### Findings, Conclusions and Decision Public Works Variance EN-22-0049

Site: The Reserve Typical Minor Arterial Roadway Section Variance  
Parcel No. 0222323134

**RE: The Reserve — CPH Project No. 0228-21-001**  
**Request for Public Works Standards Variance EN-22-0049**  
**Roadway Section Minor Arterial Residential**

Figure 7  
99th Street Sight Distance

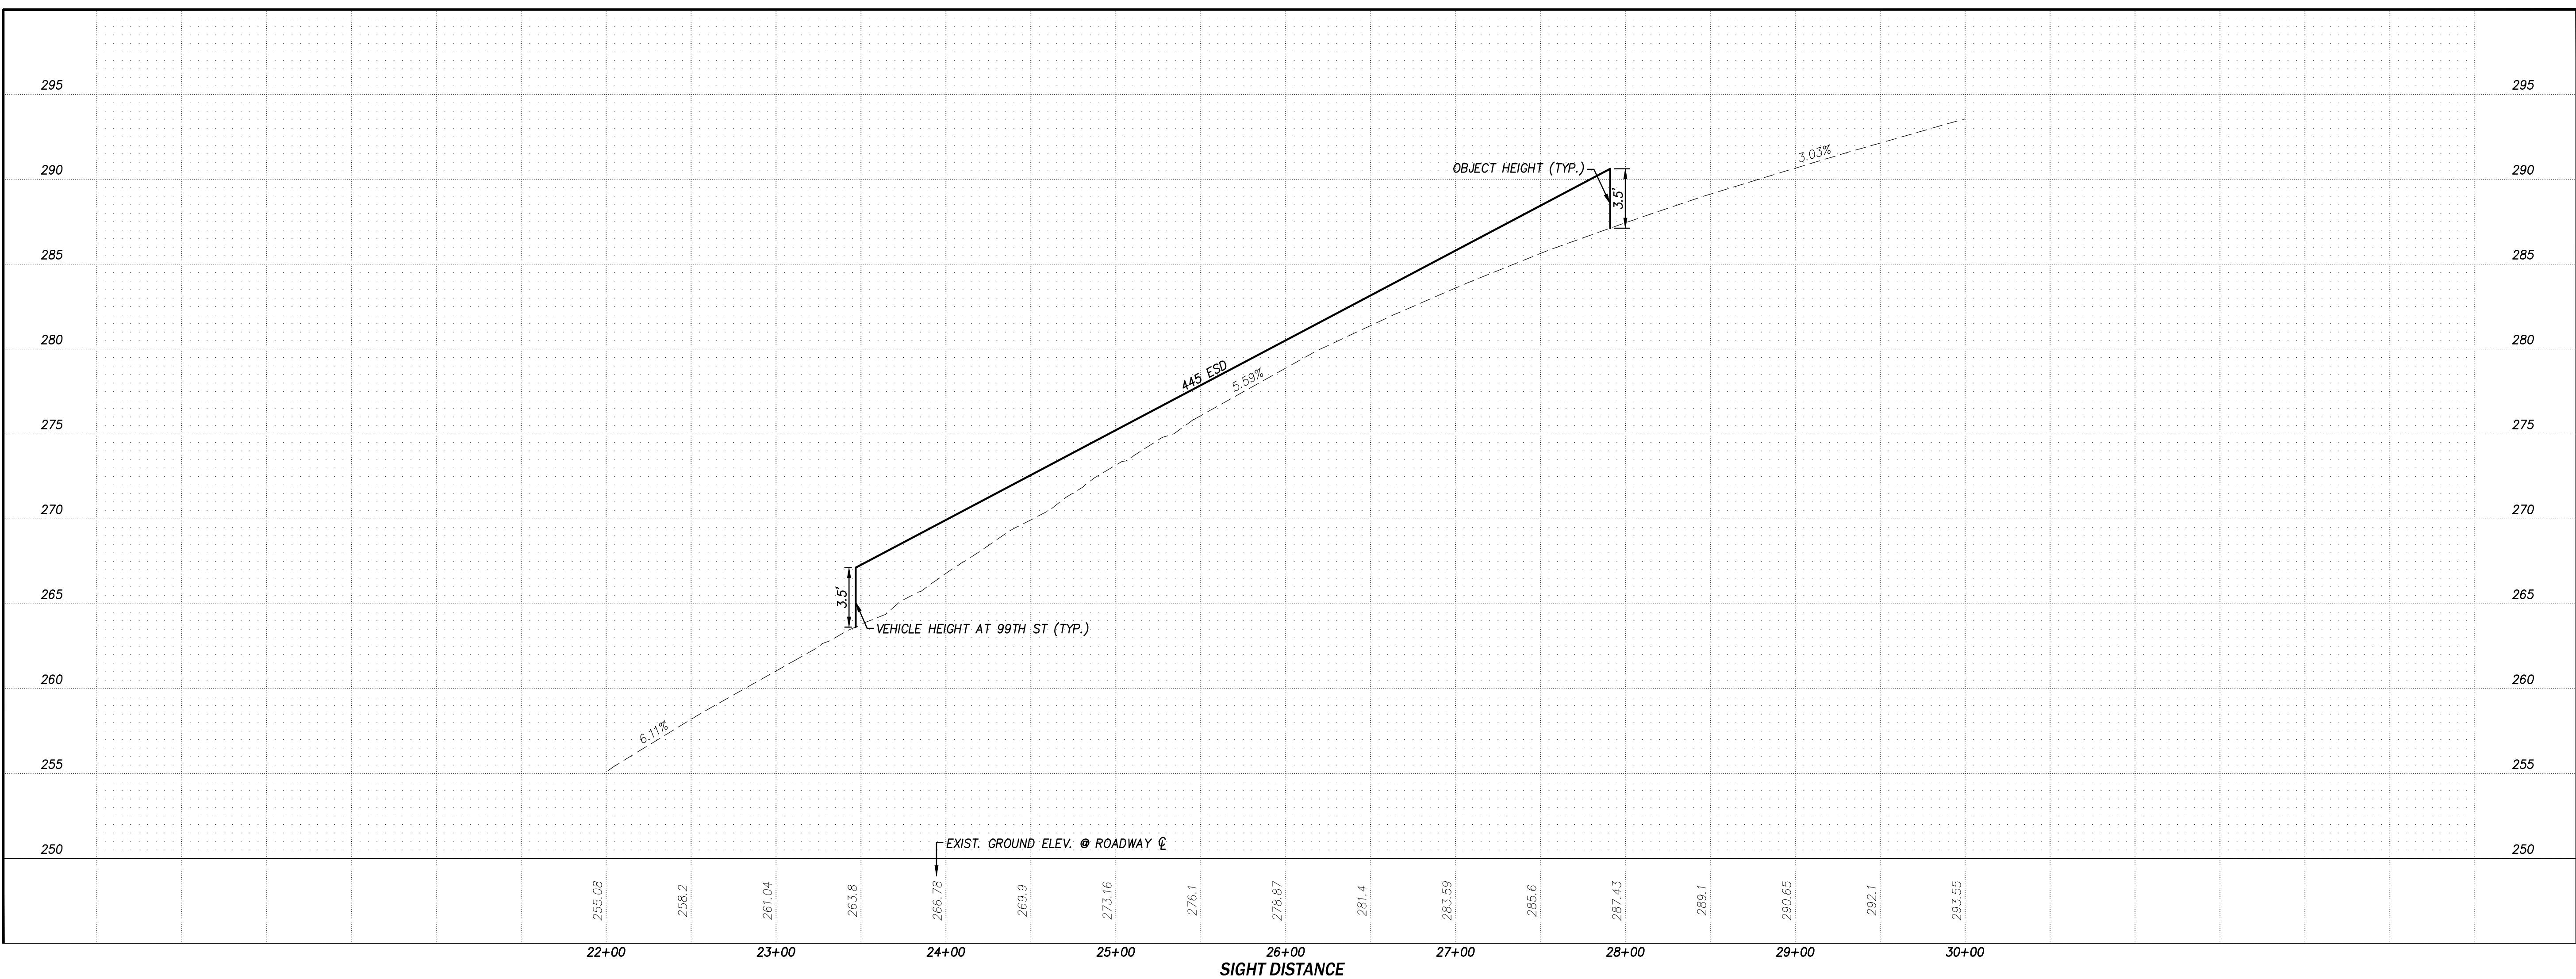
A review of the safety related to installing a crosswalk with RRFB is also provided. To assess the safety, Entering Sight Distance (ESD) from the closest intersection north and south of the proposed crosswalk location was established. The attached Figure 6, *Road A and Peacock Hill Sight Distance* shows the ESD from the closest intersection north of the crosswalk. The ESD is determined based on AASHTO, *A Policy on Geometric Design for Highways and Streets, 2018, 7<sup>th</sup> Edition* (AASHTO) requirements, specifically, Section 9.5.2.3, Table 9-7, for a left turn from stop, Peacock Hill Avenue. requires an ESD of 445 feet based on a 40 mph design speed, is calculated as the minimum necessary for a vehicle to make a safe decision when turning onto Peacock Hill Avenue. Figure 7 illustrates that the available ESD for the 99<sup>th</sup> Street and Peacock Hill Avenue intersection exceeds the 445 feet minimum.

Figure 8  
Crosswalk Stopping Sight Distance

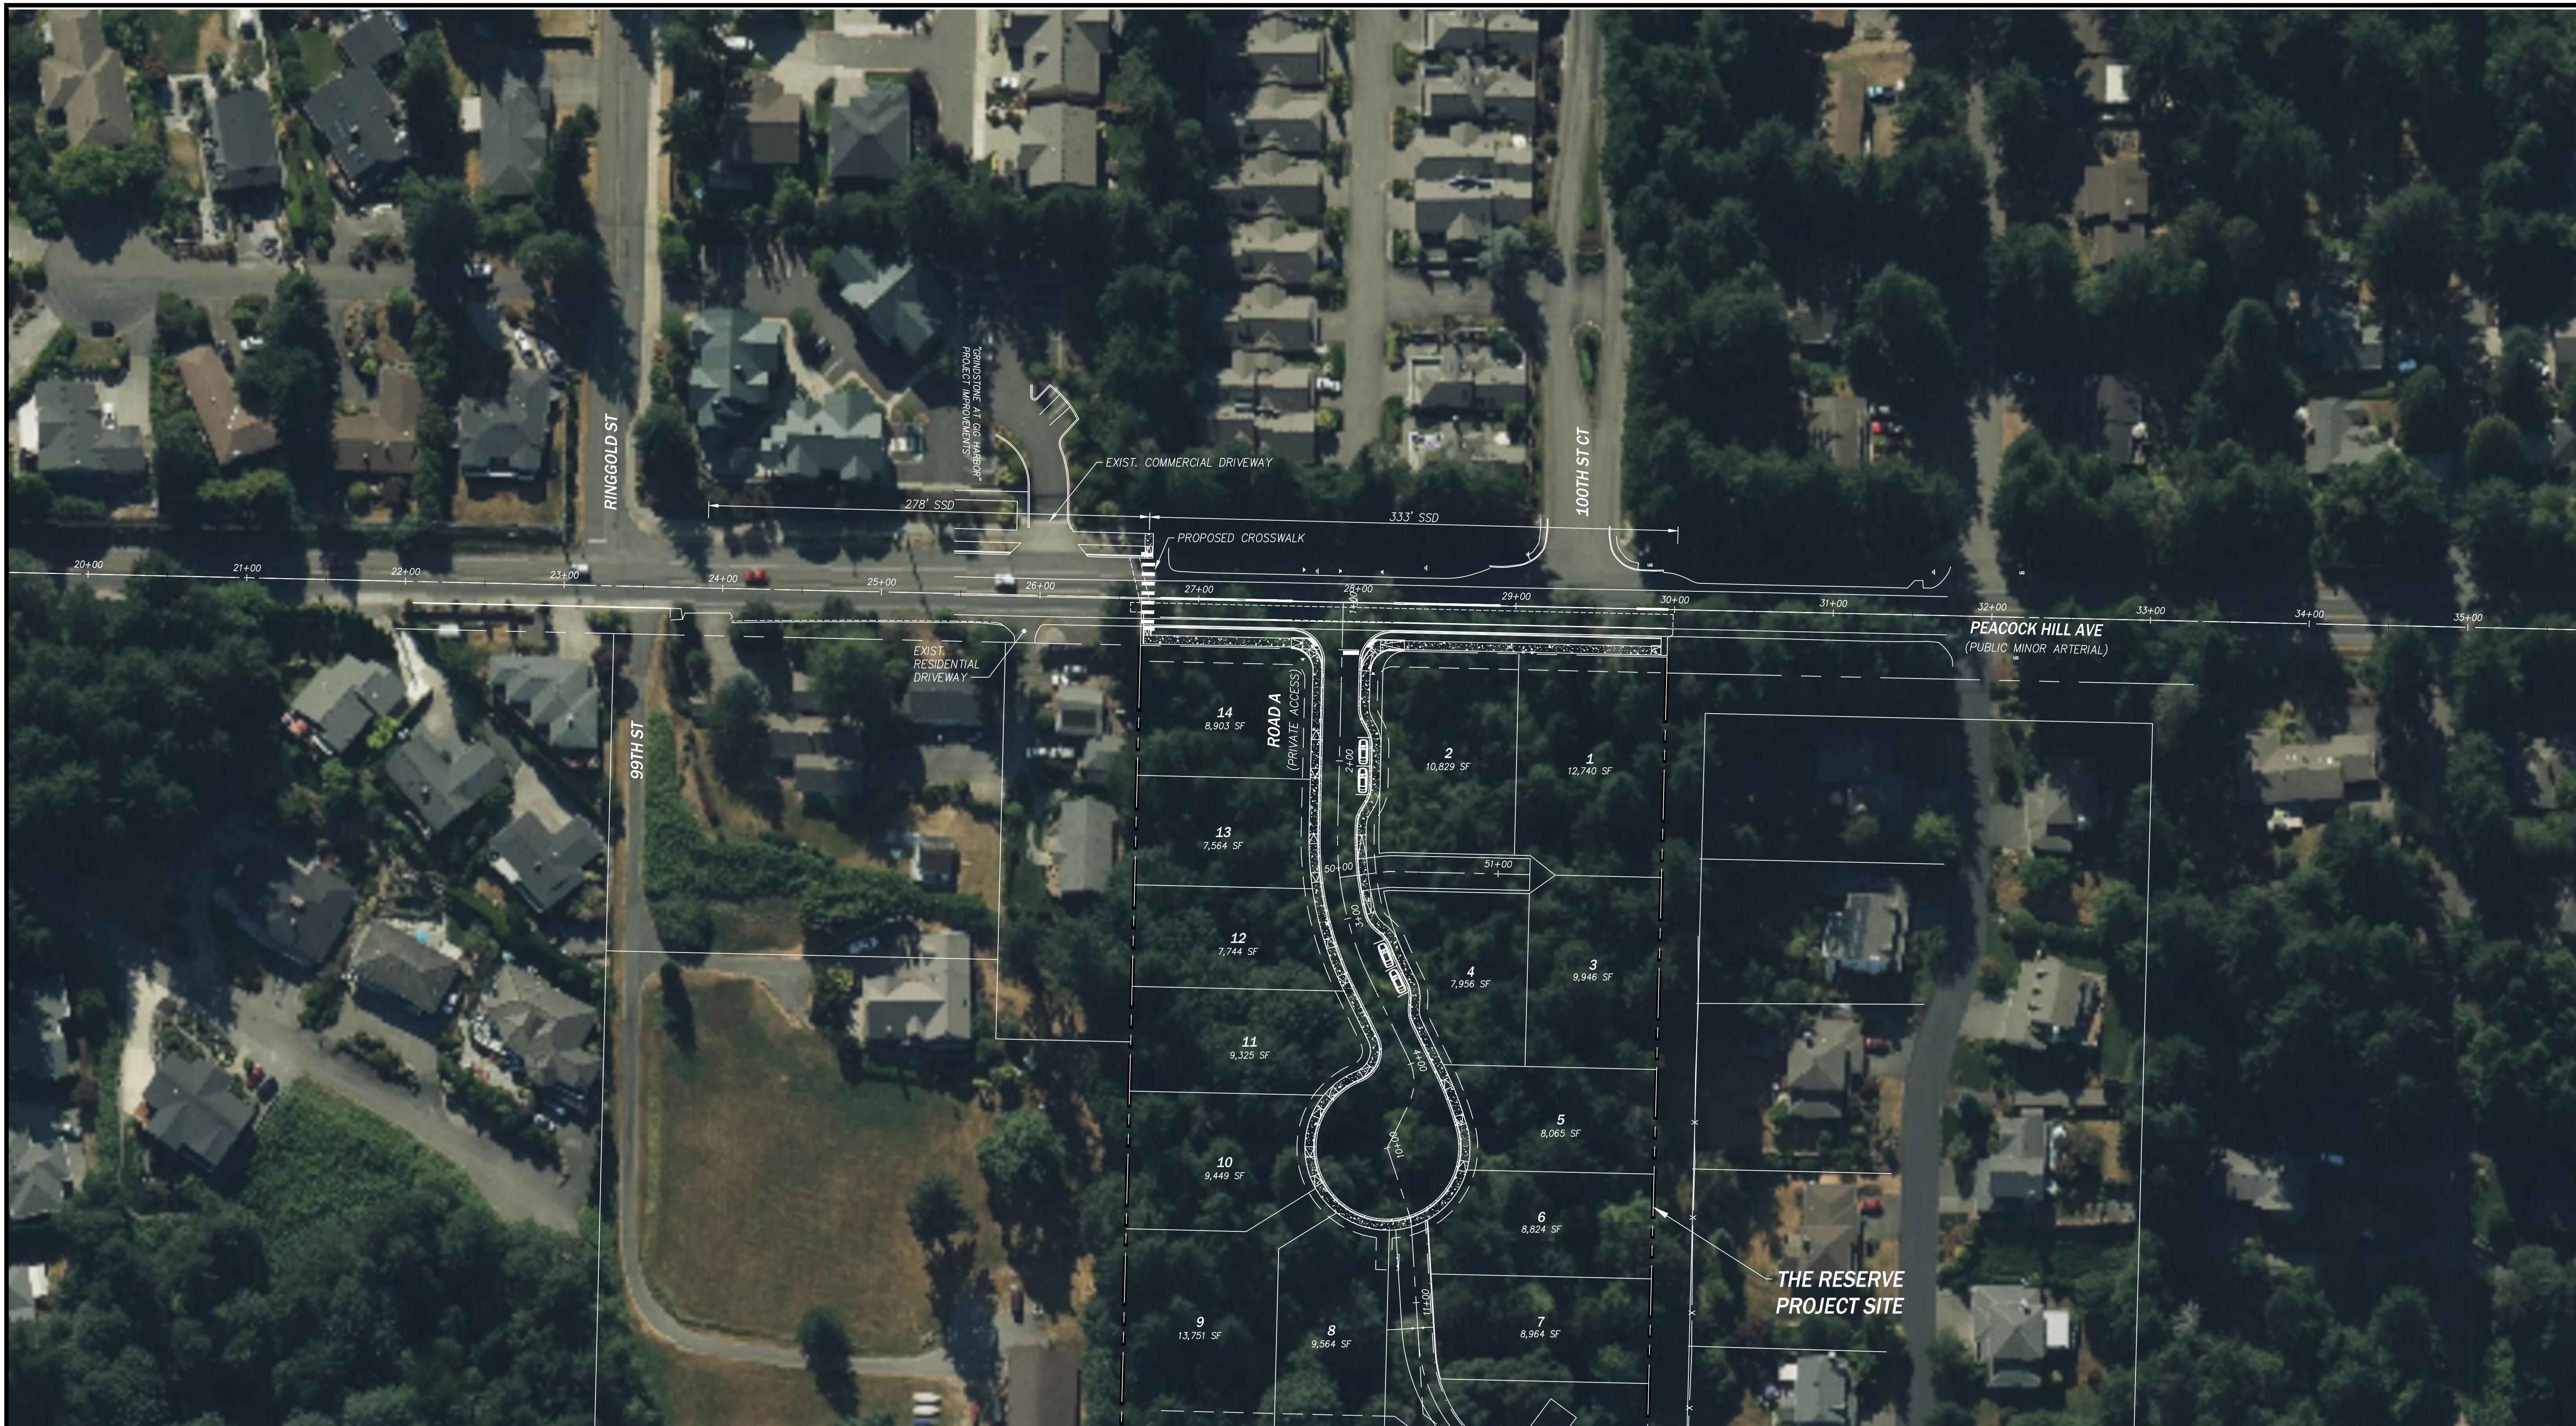
Stopping Sight Distance (SSD) standards at the new crosswalk is illustrated in Figure 8, *Crosswalk Stopping Sight Distance*. The minimum SSD for the downgradient (southbound) vehicle is 333 feet and the upgradient (northbound) is 278 feet per AASHTO, Section 3.2.2, Table 3-2, *Stopping Sight Distance on Grades* for a 40 mph design speed with a 6% grade (Peacock is approximately 3-4% grade in this area).
